68-64 LOT-19 BROOKSIDE ROAD

BP Lot 19 Brookside Road
Amendment #1

To construct 2-story frame dwelling house 36' x 29' with open 10' x 10' breezeway and 2-car garage 22' x 21'.

AP Lot 19 Brookside Road

Sketch plan showing proposed changes in plumbing and the location of existing and proposed meters. Show water flow through submeter to non-discharge equipment or location (use additional sheet of paper if necessary).

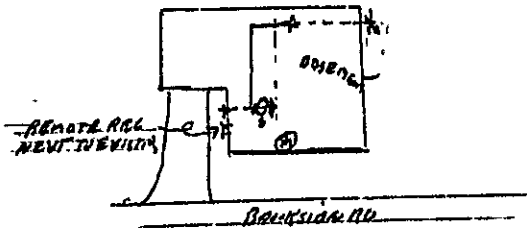
Cut in submeter, cap existing lines, run new line from sub meter to existing outside sillcock line

A WATTS ON Back Flow Preventer or equal shall be installed ON OUT SIDE SILLCOCKS
